NORTHERN WOLVES
AIR CONDITIONING

Ref. Quote: 3112 / Date: 10/6/2026 / Rev 1

Project: **Sunrise Rye Brook - 900 King St, Rye Brook, NY 10573**

Value Engineering Mark-ups - VAV zoning, cabinet heaters, basement fan coils

A/E/T NO.
M2010

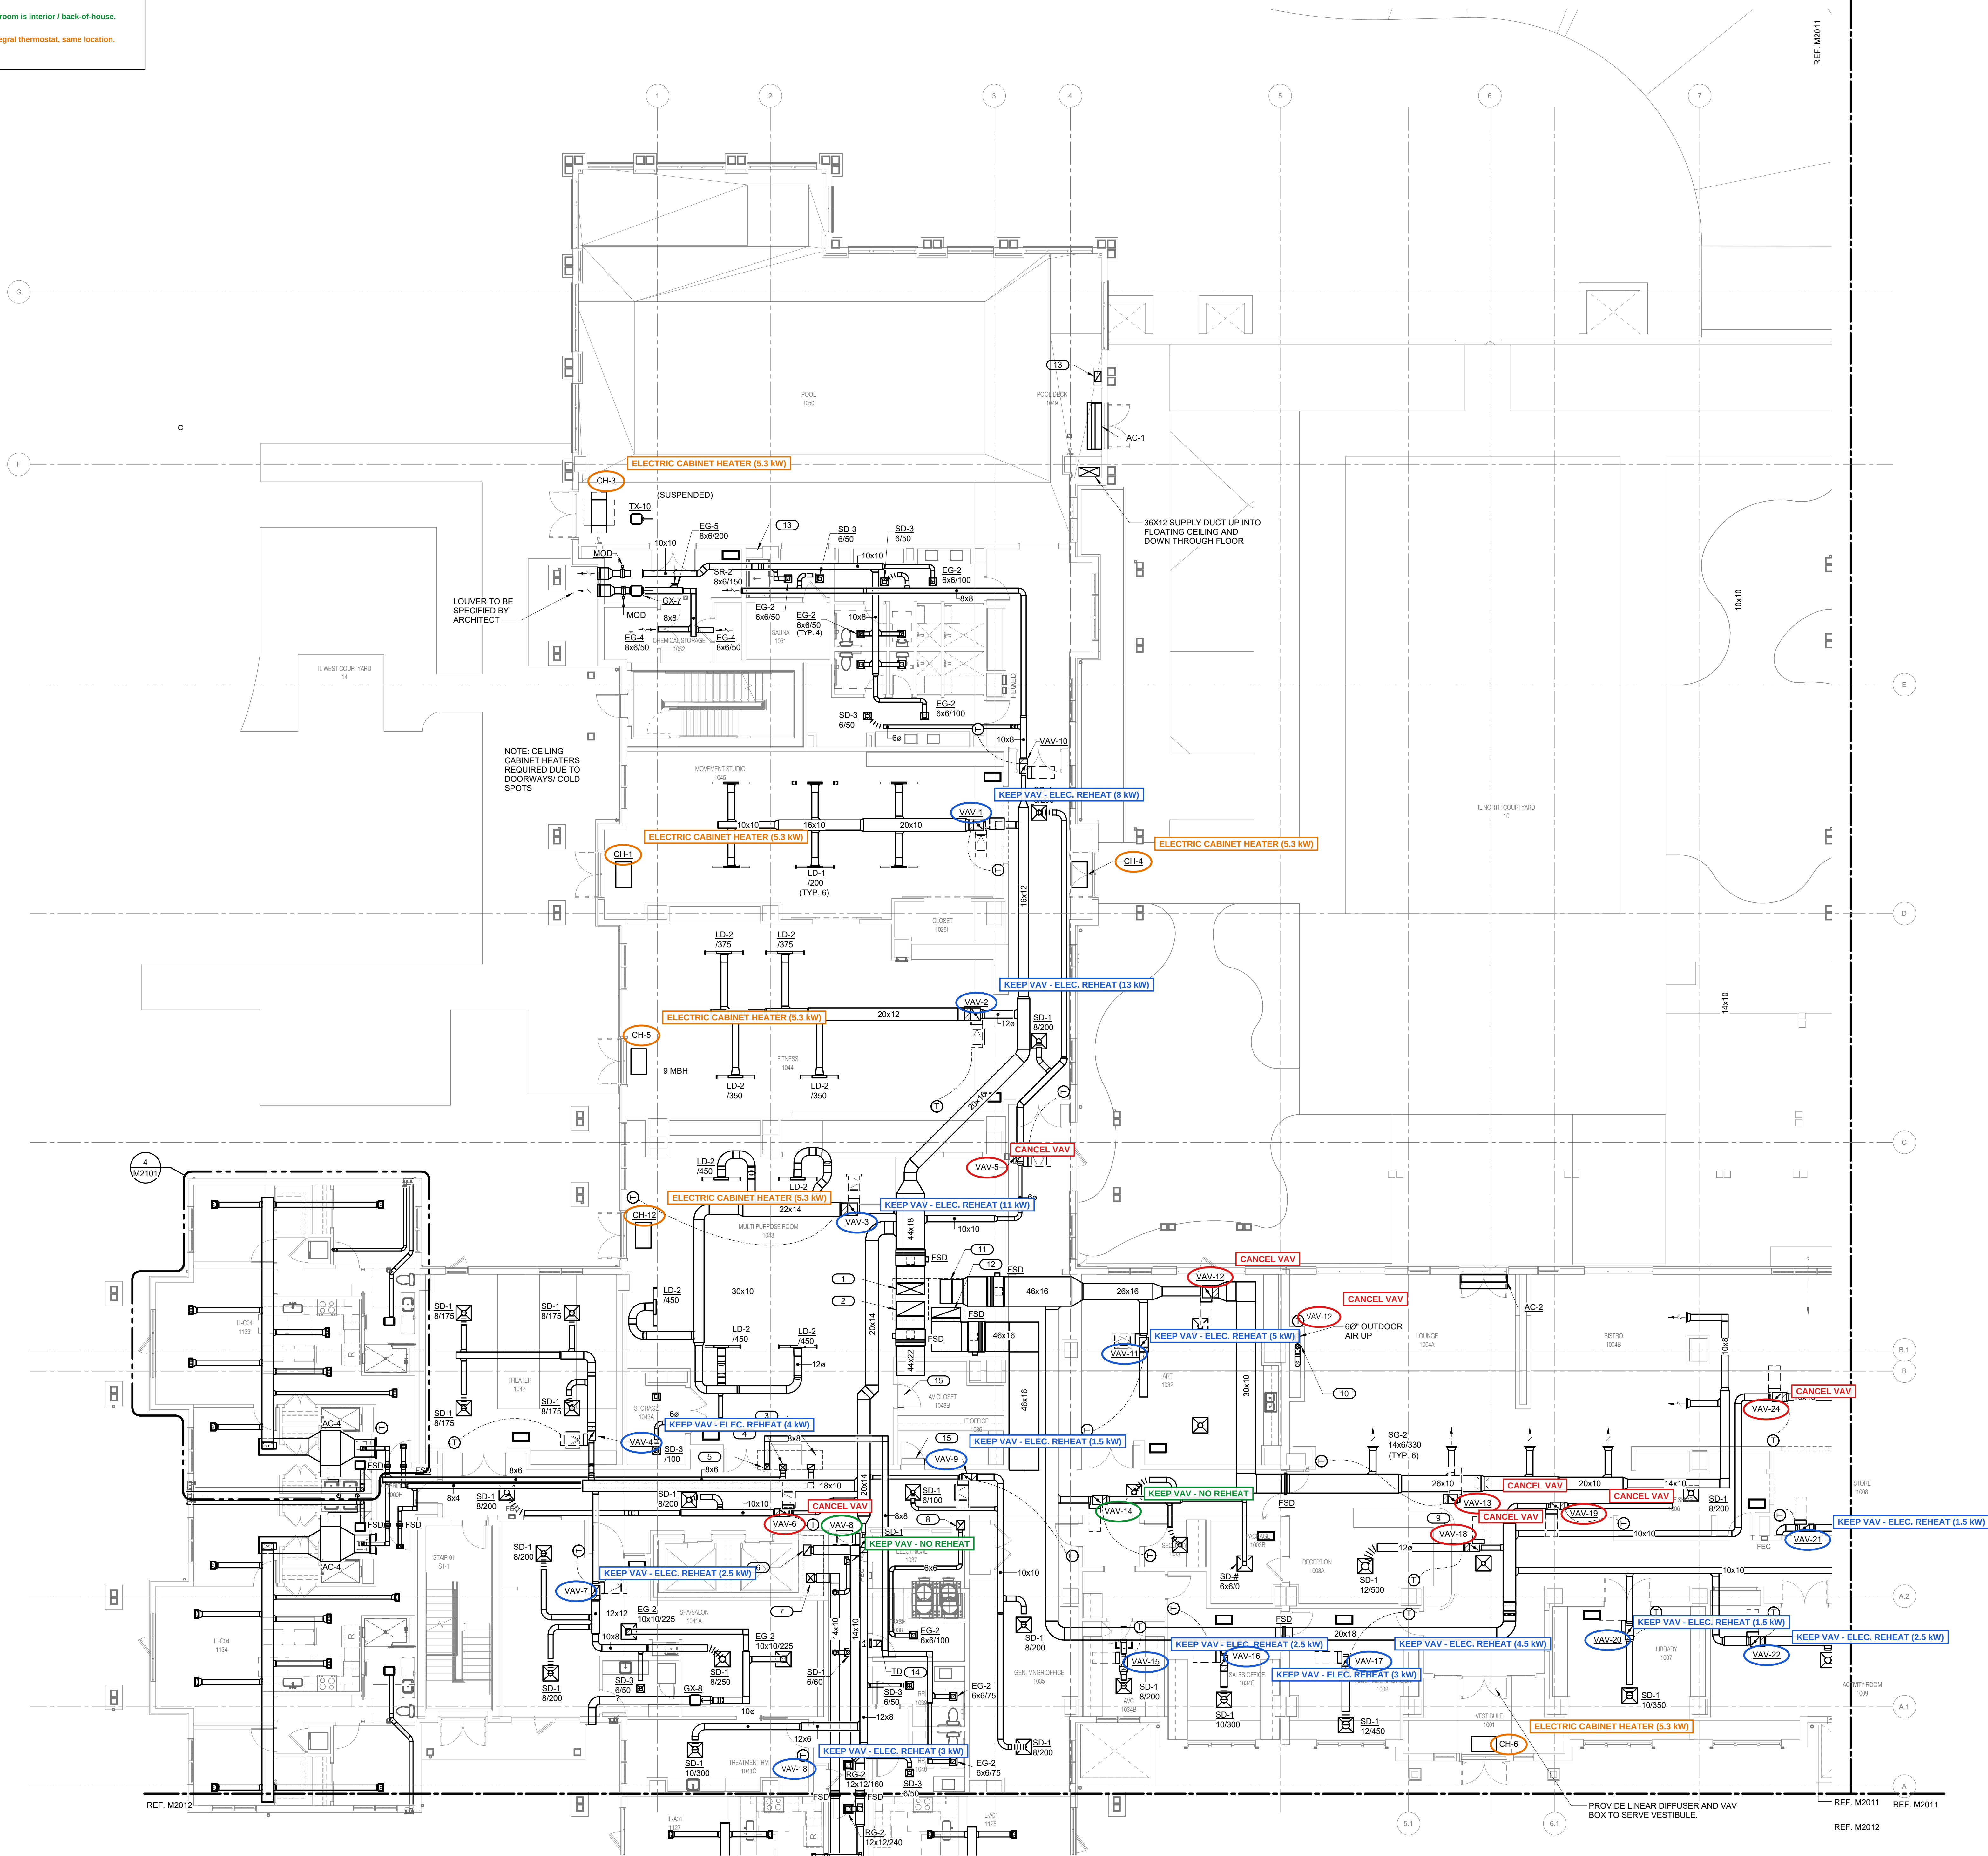
Cancel 18 / keep with electric reheat 25 / keep without reheat 4 / no change 1 (one tag, VAV-18, appears twice on M2010). Electric reheat kW = scheduled hot water reheat MBH / 3.412, rounded up to 0.5 kW (approx., final sizing by IMEG): total about 97 kW connected, versus about 185 kW if all 47 boxes were electric.

Sheet	VAV	Room / area served	Note	Proposal	Elec. heat
M2010	VAV-1	Movement Studio 1045		KEEP VAV - ELEC. REHEAT	8 kW
M2010	VAV-2	Fitness 1044		KEEP VAV - ELEC. REHEAT	13 kW
M2010	VAV-3	Multi-Purpose Room 1043		KEEP VAV - ELEC. REHEAT	11 kW
M2010	VAV-4	Theater 1042		KEEP VAV - ELEC. REHEAT	4 kW
M2010	VAV-5	Corridor / gallery		CANCEL VAV	-
M2010	VAV-6	Corridor		CANCEL VAV	-
M2010	VAV-7	Spa / Salon 1041A		KEEP VAV - ELEC. REHEAT	2.5 kW
M2010	VAV-8	IT Office 1036 / AV Closet		KEEP VAV - NO REHEAT	-
M2010	VAV-9	Gen. Manager Office 1035		KEEP VAV - ELEC. REHEAT	1.5 kW
M2010	VAV-10	Locker rooms / sauna (pool area)	Pool / sauna by others - not marked	NO CHANGE	-
M2010	VAV-11	Art 1032		KEEP VAV - ELEC. REHEAT	5 kW
M2010	VAV-12	Lounge 1004A		CANCEL VAV	-
M2010	VAV-13	Lounge / Bistro 1004A-B		CANCEL VAV	-
M2010	VAV-14	Security 1033 / Package 1003B		KEEP VAV - NO REHEAT	-
M2010	VAV-15	AVC 1034B		KEEP VAV - ELEC. REHEAT	2.5 kW

M2010	VAV-16	Sales Office 1034C		KEEP VAV - ELEC. REHEAT	3 kW
M2010	VAV-17	Family Meeting Room 1002		KEEP VAV - ELEC. REHEAT	4.5 kW
M2010	VAV-18	Reception 1003A		CANCEL VAV	-
M2010	VAV-18	Treatment Rm 1041C	Tag duplicated on drawing - clarify	KEEP VAV - ELEC. REHEAT	3 kW
M2010	VAV-19	Coffee Shop 1006		CANCEL VAV	-

Sheet	VAV	Room / area served	Note	Proposal	Elec. heat
M2010	VAV-20	Library 1007		KEEP VAV - ELEC. REHEAT	1.5 kW
M2010	VAV-21	Store 1008		KEEP VAV - ELEC. REHEAT	1.5 kW
M2010	VAV-22	Activity Room 1009		KEEP VAV - ELEC. REHEAT	2.5 kW
M2010	VAV-24	Bistro 1004B		CANCEL VAV	-
M2011	VAV-23	Restrooms 1012-1013 / Mailroom		CANCEL VAV	-
M2011	VAV-25	Casual Dining 1015		CANCEL VAV	-
M2011	VAV-26	Private Dining 1016		KEEP VAV - ELEC. REHEAT	2.5 kW
M2011	VAV-27	Formal Dining 1017		CANCEL VAV	-
M2011	VAV-28	Restrooms / kitchen corridor		CANCEL VAV	-
M2011	VAV-29	Main Kitchen 1019		CANCEL VAV	-
M2011	VAV-30	Private Dining 130 / Dry Storage		KEEP VAV - ELEC. REHEAT	2.5 kW
M2011	VAV-31	Storage 1031 / Trash 1030 / Receiving		KEEP VAV - NO REHEAT	-
M2011	VAV-32	Chef Office 1027		KEEP VAV - NO REHEAT	-
M2011	VAV-33	AL Dining 128		CANCEL VAV	-
M2013	VAV-34	Bistro 127		CANCEL VAV	-
M2013	VAV-35	Bistro / dining 127		CANCEL VAV	-

M2013	VAV-36	Parlor 131		CANCEL VAV	-
M2013	VAV-37	Reception 126		CANCEL VAV	-
M2013	VAV-38	Family Room 120		KEEP VAV - ELEC. REHEAT	3.5 kW
M2013	VAV-39	Work Room / Sales / Exec. Director		KEEP VAV - ELEC. REHEAT	3 kW
M2013	VAV-40	Corridor 100C		CANCEL VAV	-
M2013	VAV-41	Salon 132A		KEEP VAV - ELEC. REHEAT	1.5 kW
M2013	VAV-42	Theater 135		KEEP VAV - ELEC. REHEAT	2.5 kW
M2013	VAV-43	Activity 136		KEEP VAV - ELEC. REHEAT	4 kW
M2013	VAV-44	Fitness 141		KEEP VAV - ELEC. REHEAT	5 kW
M2013	VAV-45	Fitness / Wellness Office		KEEP VAV - ELEC. REHEAT	3.5 kW
M2013	VAV-46	Wellness Office		KEEP VAV - ELEC. REHEAT	2.5 kW
M2013	VAV-47	Exam / AVC Office		KEEP VAV - ELEC. REHEAT	3 kW
		Total electric reheat			97 kW

Sheet	Tag	Location	Proposal	Elec. heat
M2010	CH-1	Movement Studio entry	ELECTRIC CABINET HEATER	5.3 kW
M2010	CH-3	Pool deck / stair entry	ELECTRIC CABINET HEATER	5.3 kW
M2010	CH-4	Exterior door at gallery	ELECTRIC CABINET HEATER	5.3 kW
M2010	CH-5	Fitness entry	ELECTRIC CABINET HEATER	5.3 kW
M2010	CH-12	Multi-Purpose Room entry	ELECTRIC CABINET HEATER	5.3 kW
M2010	CH-6	Vestibule 1001	ELECTRIC CABINET HEATER	5.3 kW
M2011	CH-7	Formal Dining entry	ELECTRIC CABINET HEATER	5.3 kW
M2011	CH-9	Trash 1030 / Storage	ELECTRIC CABINET HEATER	10.4 kW
M2011	CH-10	Casual Dining entry	ELECTRIC CABINET HEATER	5.3 kW
M2011	CH-11	Casual Dining entry	ELECTRIC CABINET HEATER	5.3 kW
		Total (scheduled MBH / 3.412)		58.1 kW

Sheet M2011 (GMP set 07.15.2026). For discussion - not a design document.

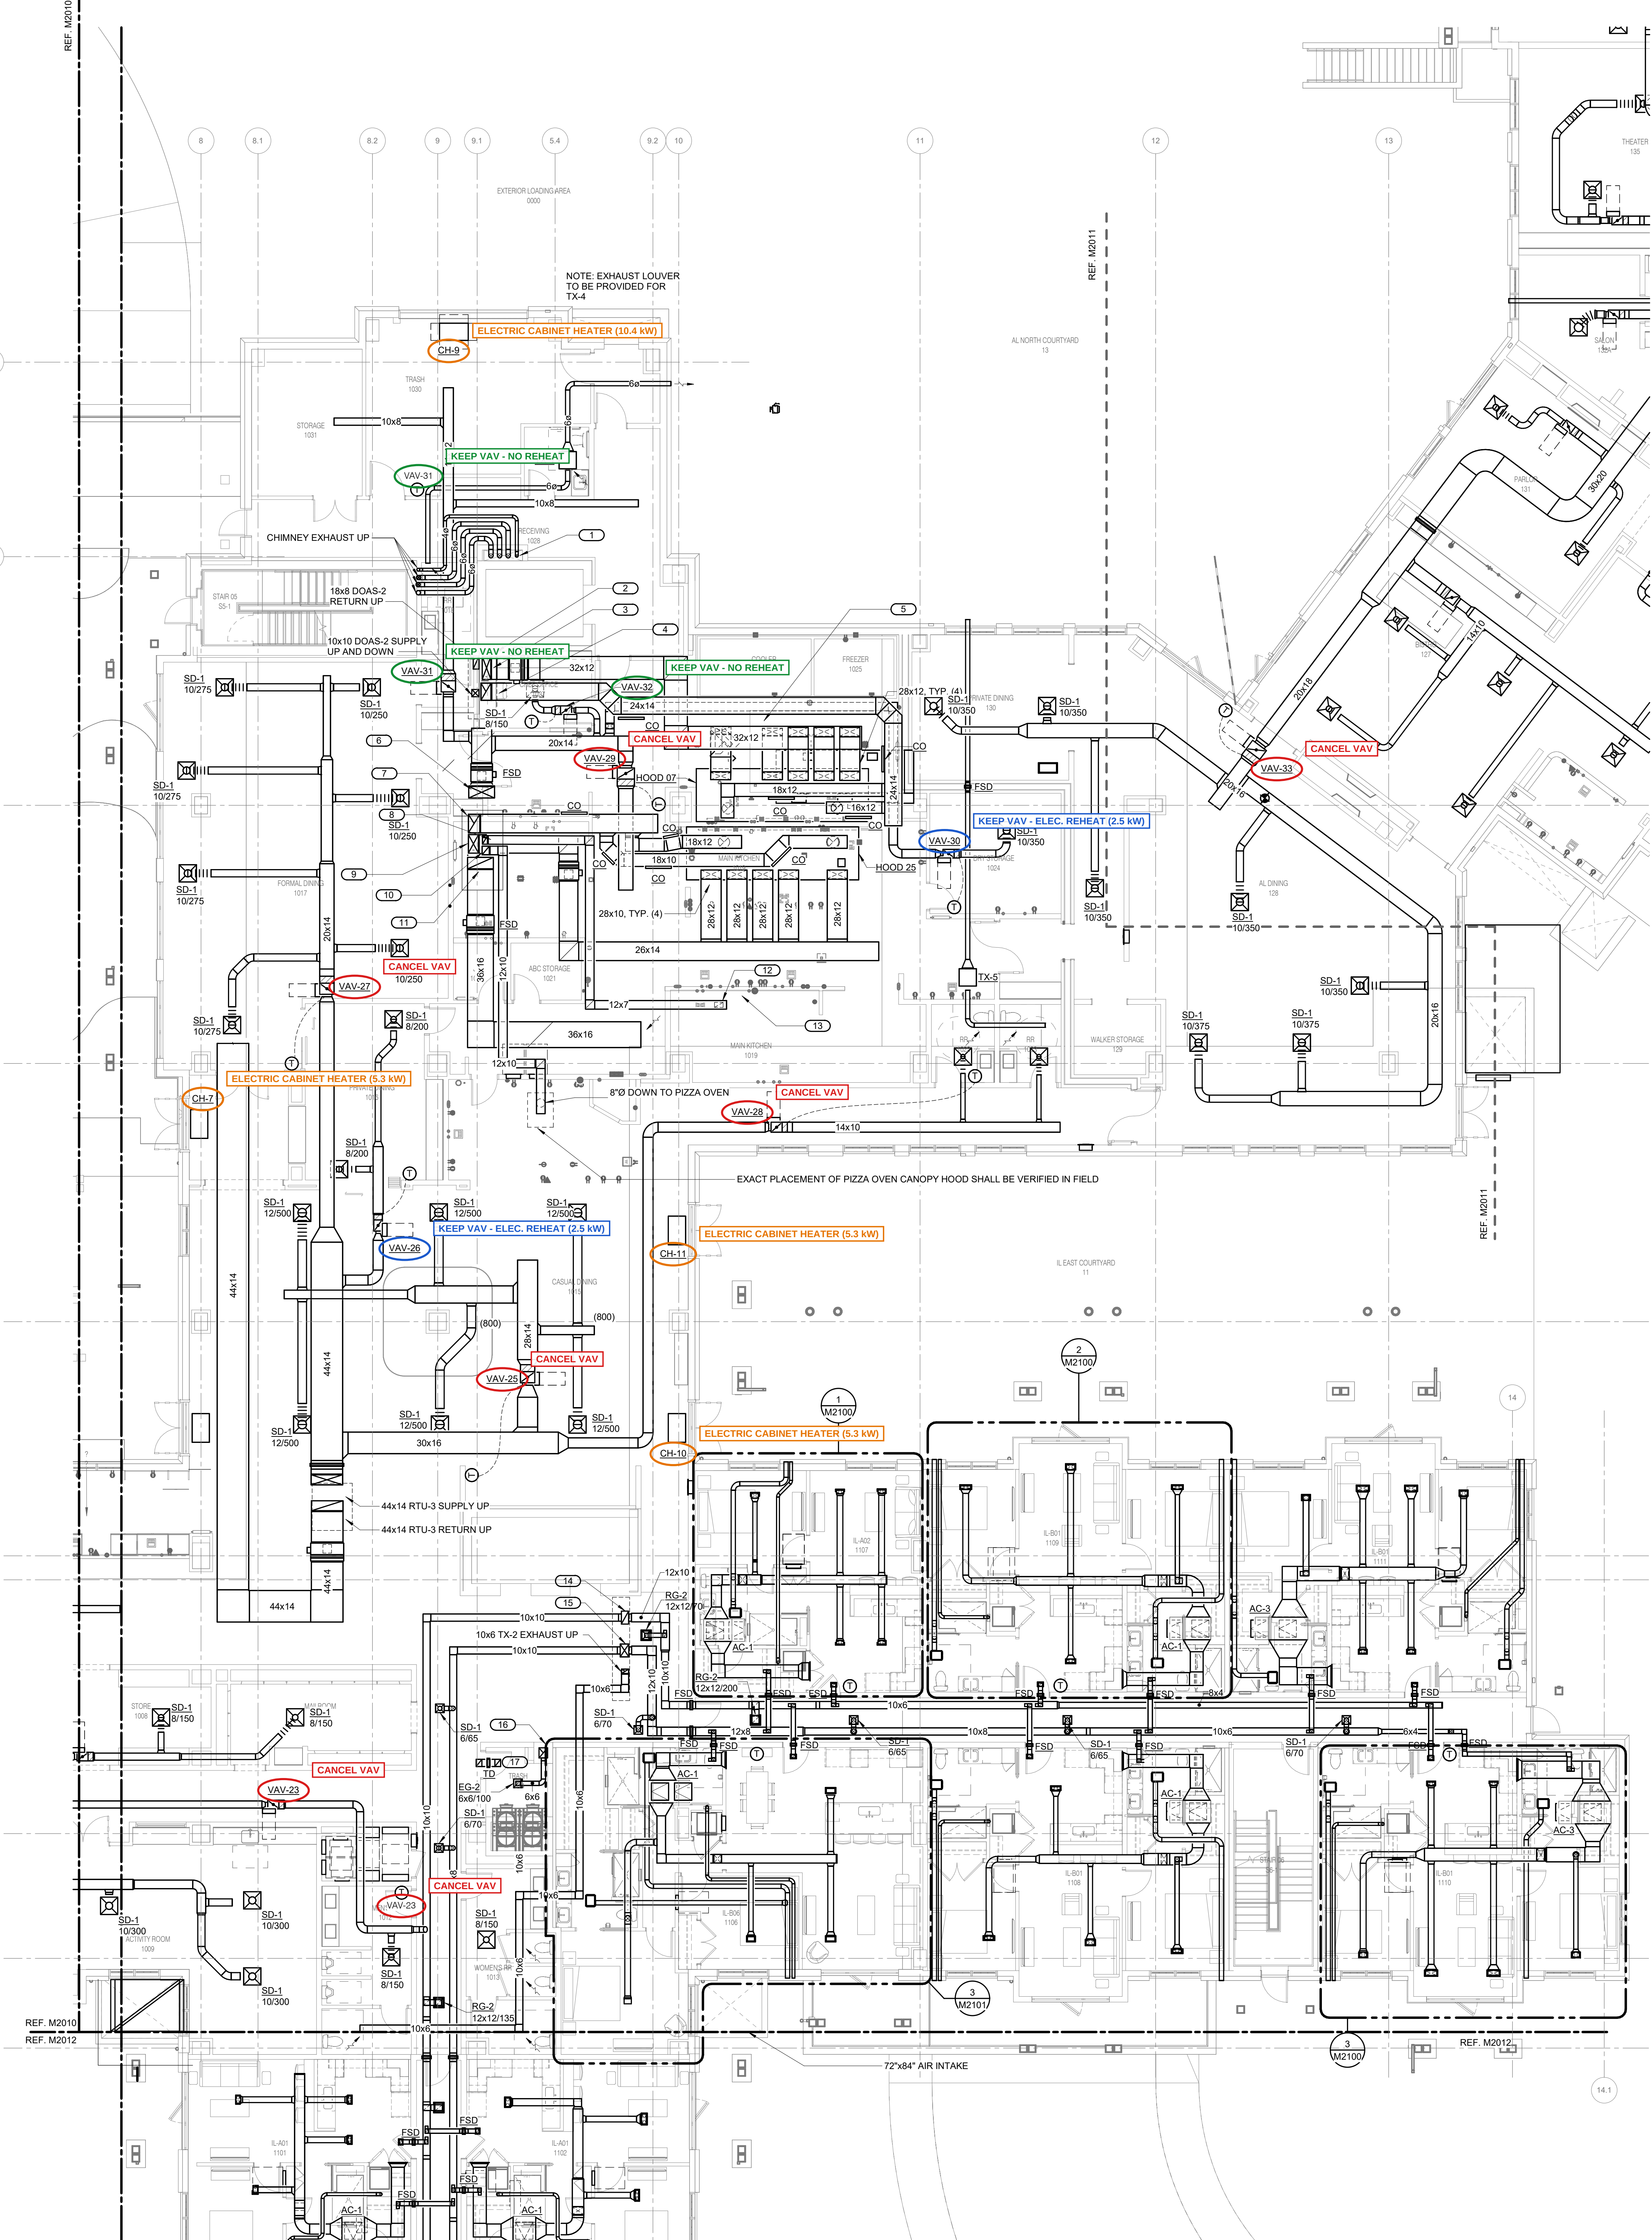
CANCEL VAV (8): Cancel VAV box (open area / circulation). Branch duct stays with manual volume damper, balanced to design max CFM; area served directly by the RTU (RTU space sensor here). Gas heat from the RTU.

KEEP VAV - ELEC. REHEAT (2): Keep VAV box. Electric reheat coil with SCR in lieu of hot water coil; simple standalone thermostat. No hot water piping or control valve.

KEEP VAV - NO REHEAT (2): Keep VAV box, cooling only. No reheat required; RTU is gas heat and the room is interior / back-of-house. Standalone thermostat.

ELECTRIC CABINET HEATER (4): Replace hot water cabinet heater with electric cabinet heater with integral thermostat, same location. Delete hot water piping. Power by EC.
